Application for Variance

Project for Which Variance Is Sought: Electrical overhead

Re: Variance Review

Re: Joint variance for installation of overhead powerline

EXAMPLE
Of
How To
Tie into
a pole
& go
under
ground

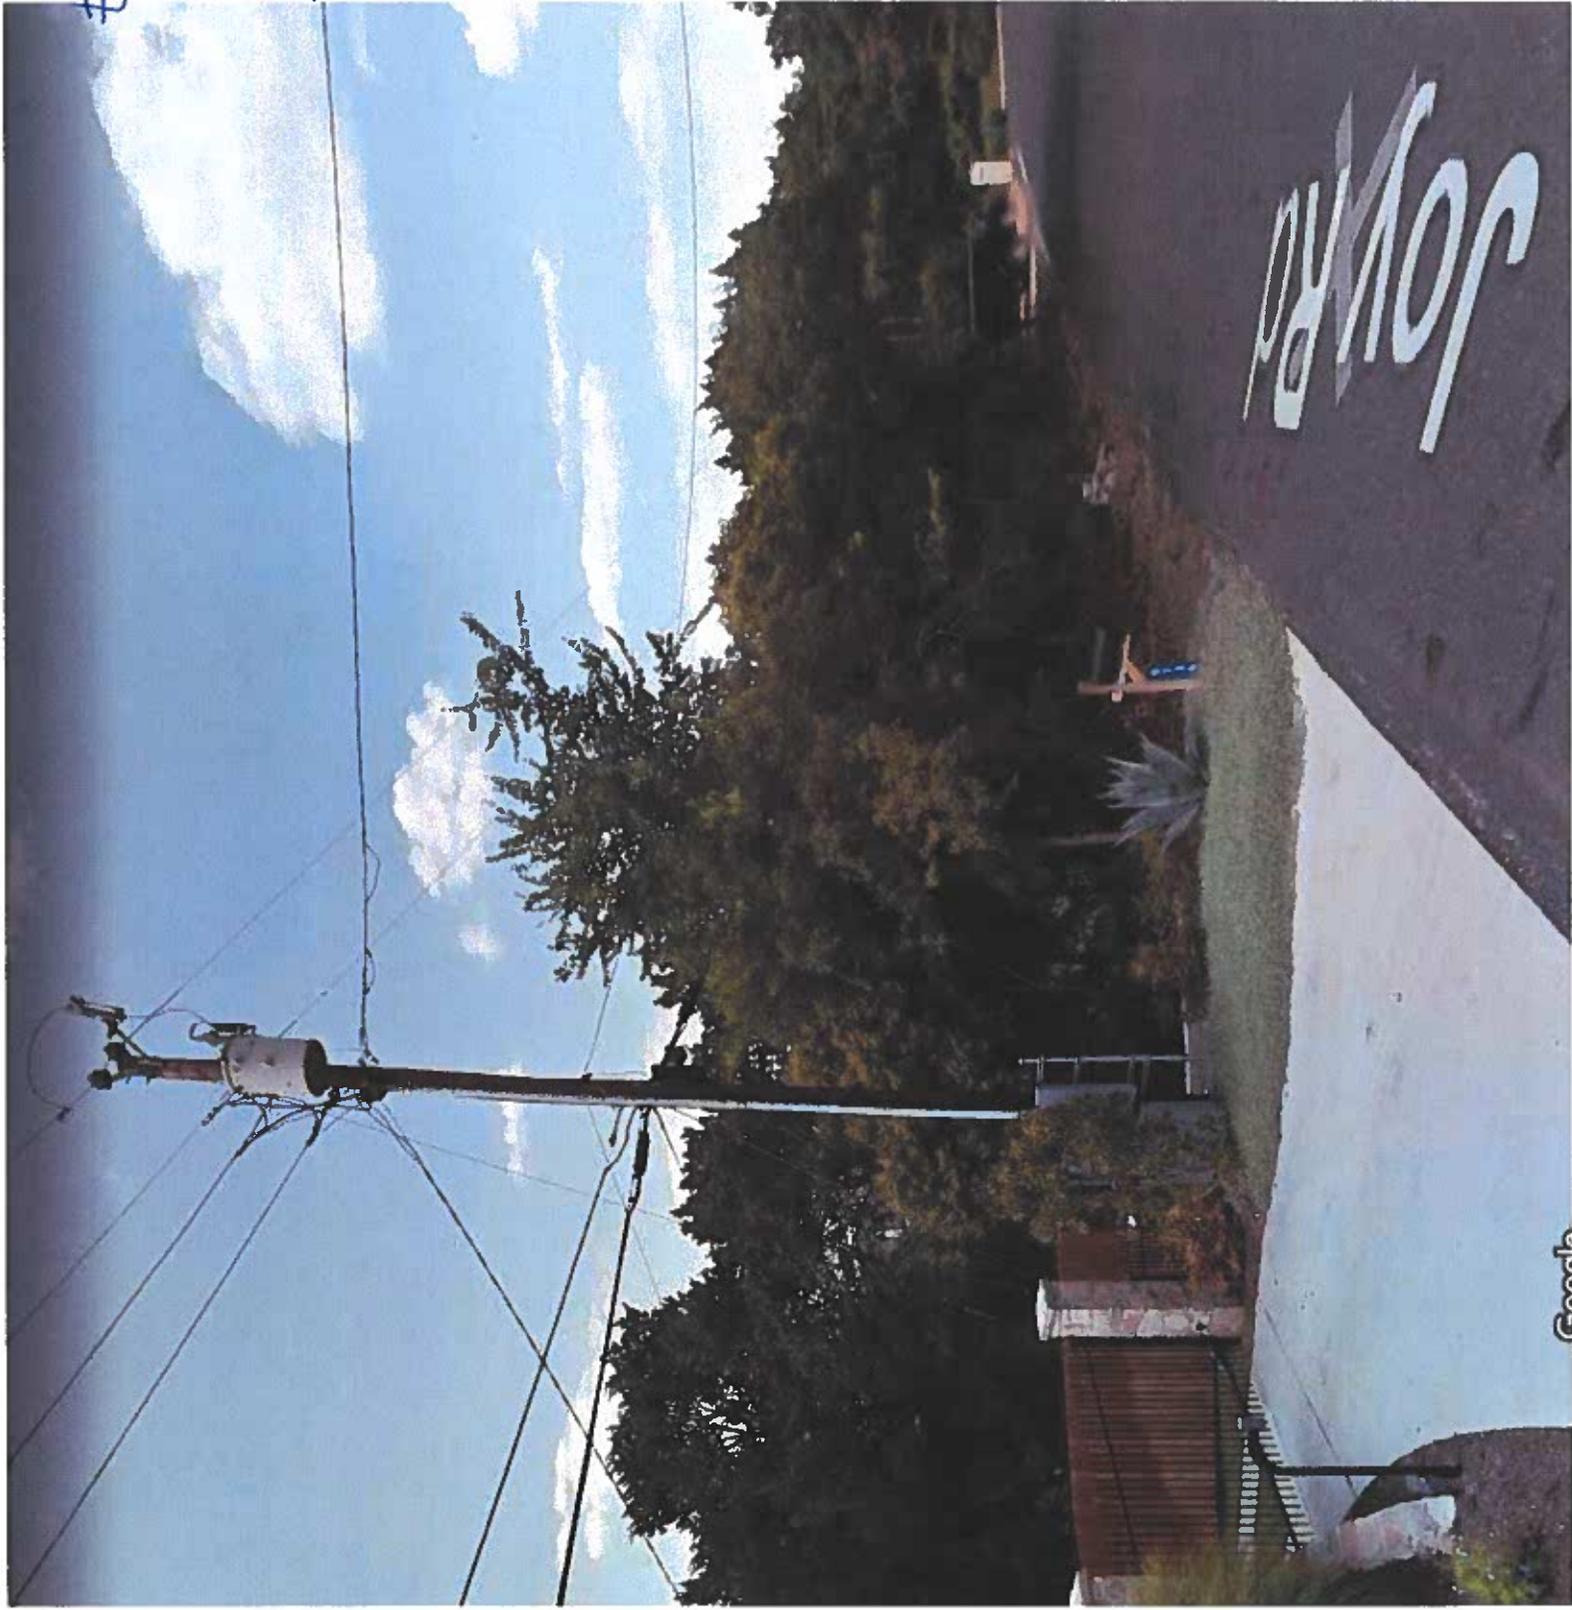
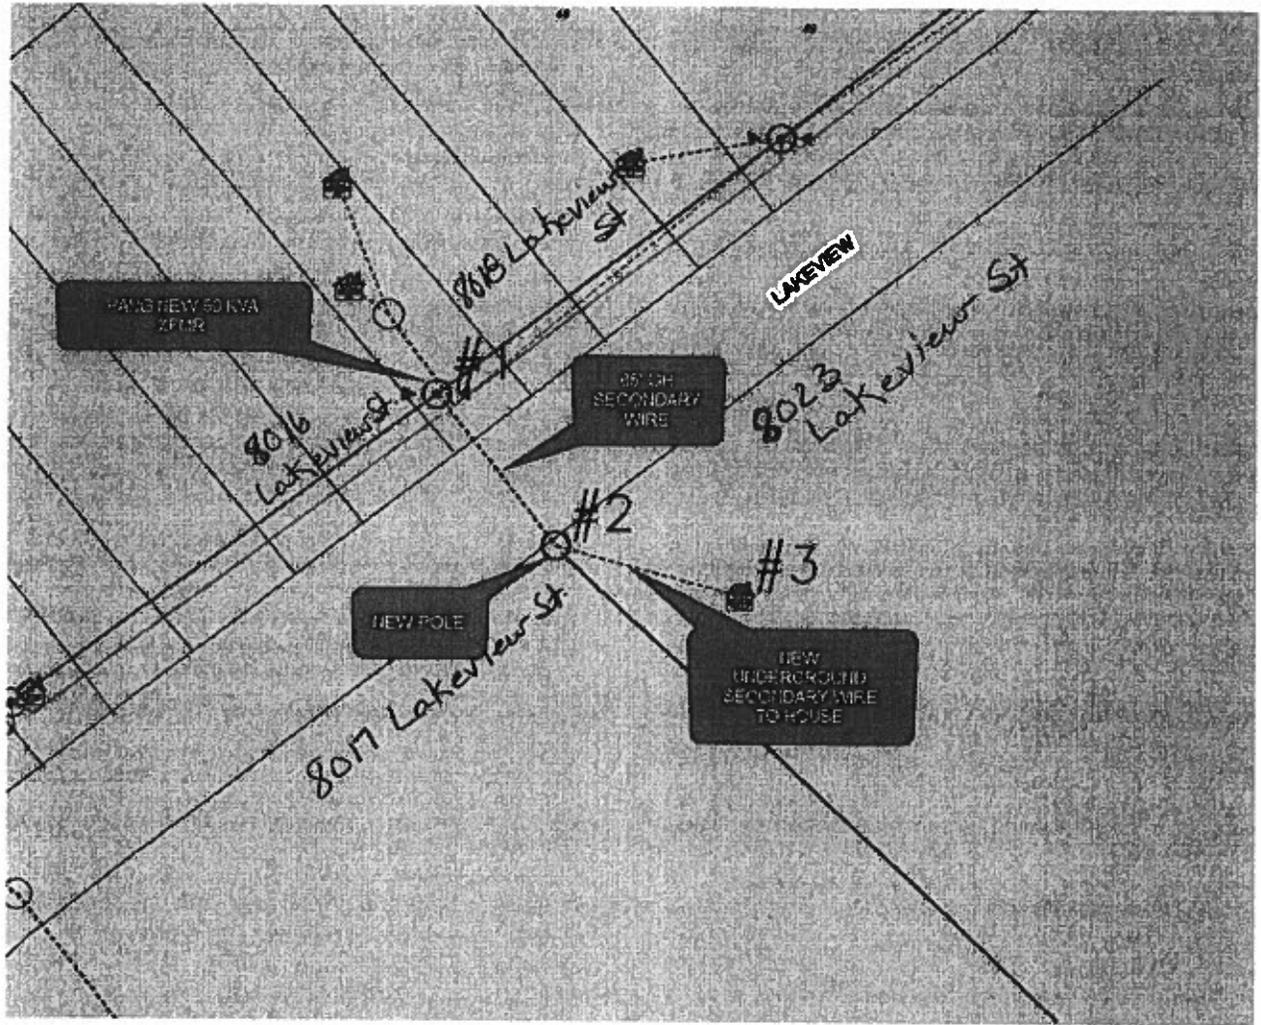
16308 Jackson: The existing overhead powerlines are on the same side of the property however PEC is requiring two poles, a pole in the PEC easement and another pole on site. This type of variance in the past was handled by one new pole and a weather head drop in the easement along the main pole which would reduce the number of poles in the Village. See the attached image.
